## TECHNICAL NOTE

**Job Name:** Land West of Park Farm, Thornbury  
**Job No:** 39209  
**Note No:** 39209/007  
**Date:** 30 April 2020  
**Prepared By:** K. Stock  
**Subject:** **PT18/6450/O Land West of Park Farm, Thornbury – Response to SGC Comments dated 2<sup>nd</sup> April 2020**

Plate 10.1: Forecast School Trips at Butt Lane - SGC 80% Assumption (AM Peak = left, PM Peak = right)

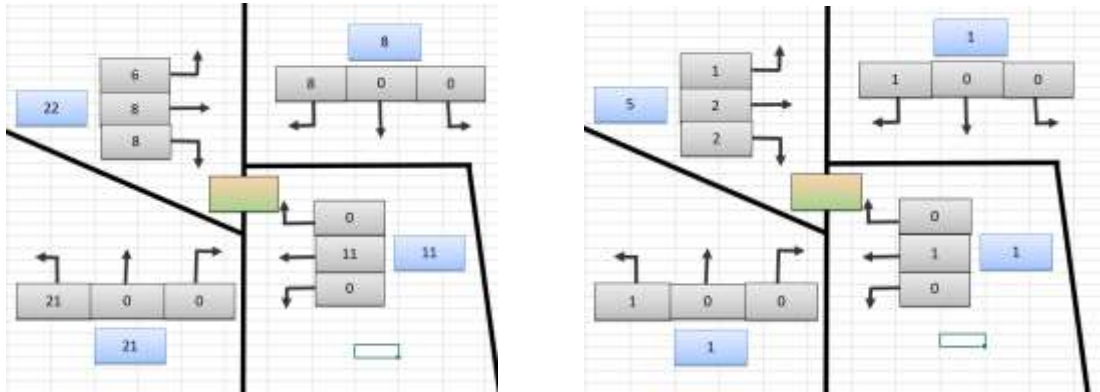
10.11. SGC has suggested that it could be assumed that 20% of vehicle trips are local to the development site and therefore not travelling through the Butt Lane junction as part of a school trip. Whilst Stantec consider that this is an overly robust assumption (see Para's 10.2 and 10.4 of this Note), this has been applied as a robust assessment of vehicular trips that could be associated with the school. The resultant vehicle trips are set out in **Table 10.2**.

- 10.13. [Table 10.2](#) and [Plate 10.1](#) demonstrate that the school could be associated with up to 52 two-way vehicle movements in the AM peak hour through the Butt Lane junction, equating to less than one additional vehicle per minute, on average.

- 10.14. However, as stated above, should the proposed school attract pupils from outside the immediate catchment, it must be the case that most of those trips will already be on the local highway network associated with other residential developments within Thornbury and will have been assessed through other planning applications. On this basis, there will already be a number of these trips passing through the Butt Lane junction associated with school trips elsewhere (either through observed surveys, or through our assessment as committed development trips). [Appendix D](#) demonstrates that vehicles routing from existing residential areas to the east of the Butt Lane junction would already be passing through the Butt Lane junction to reach other schools.

- 10.15. Therefore, it is considered that the actual number of new vehicle trips, not already accounted for within the modelling of the junction, will be significantly less, and negligible to the operation of the junction.

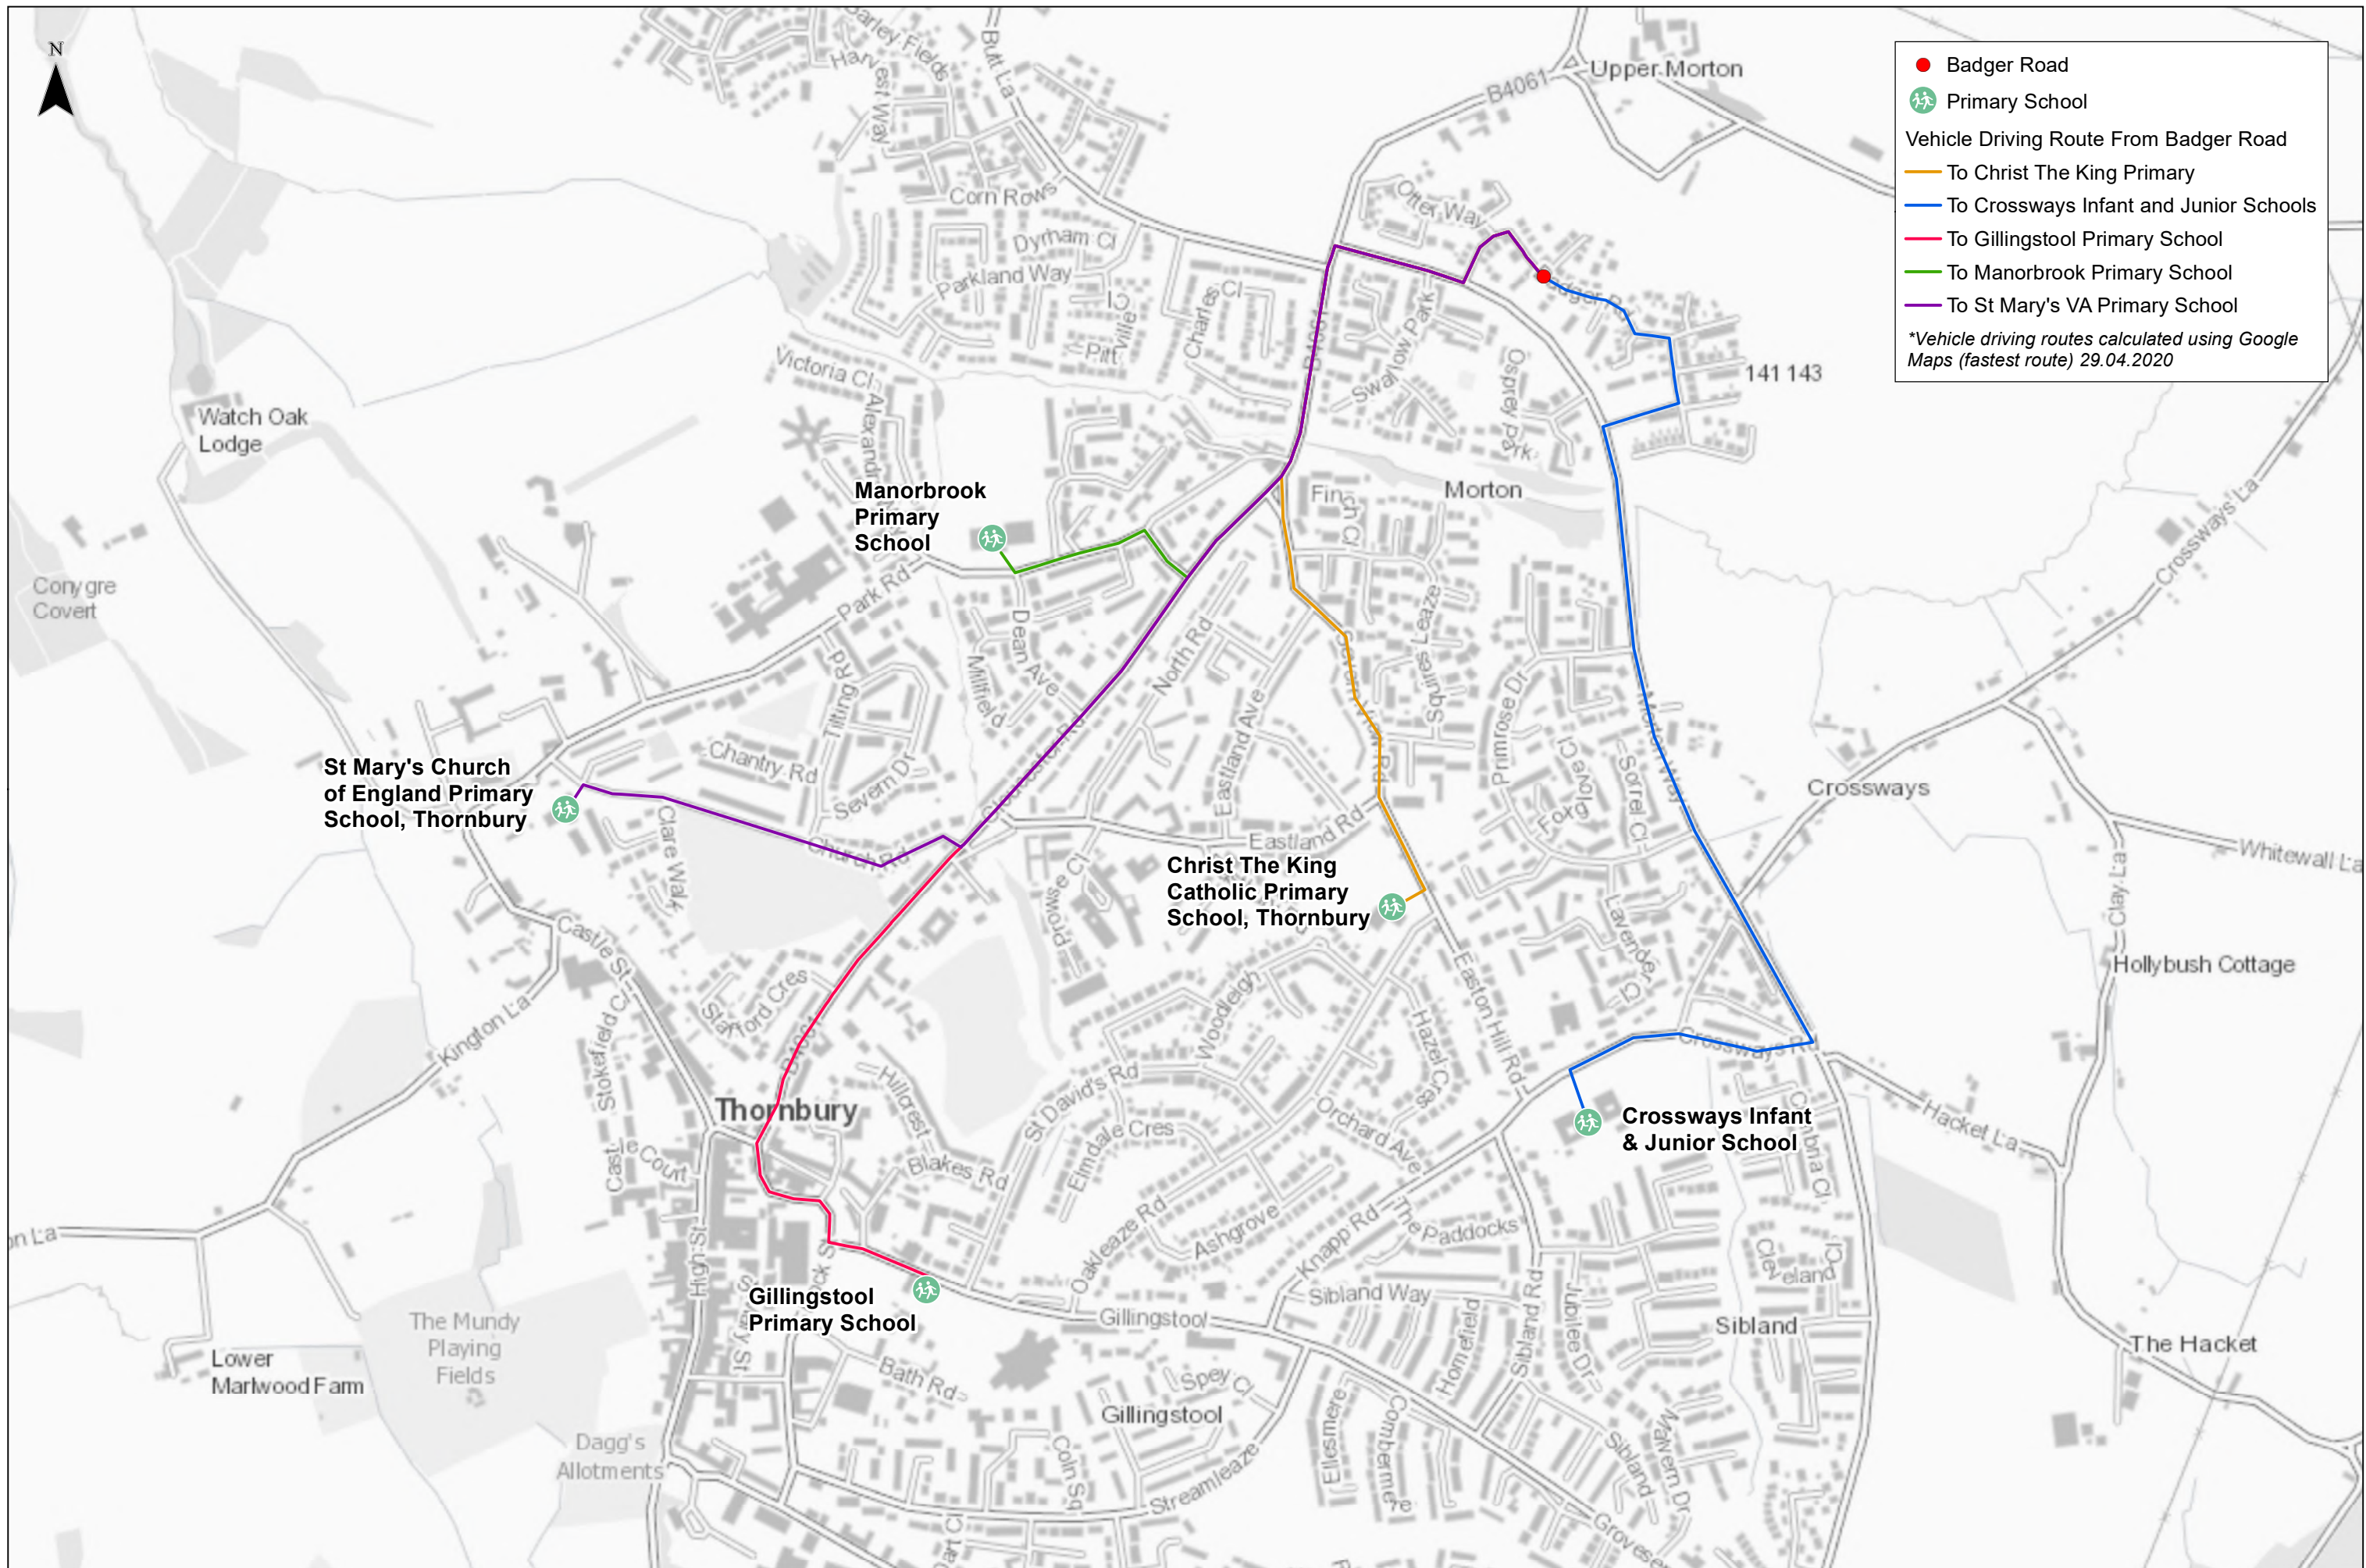
1. Morton Way crossing –
  - a. your request for this to be located at the stop line is noted and this has been updated on the proposed layout drawing and within the LinSig model – see attached drawing 39209/5501/SK08-G. We will obtain a RSA for this version of the design.

- a. A section of the hedgerow may need to be removed in order to provide the footway on the northern side of Butt Lane due to the limited land available within the adopted highway.
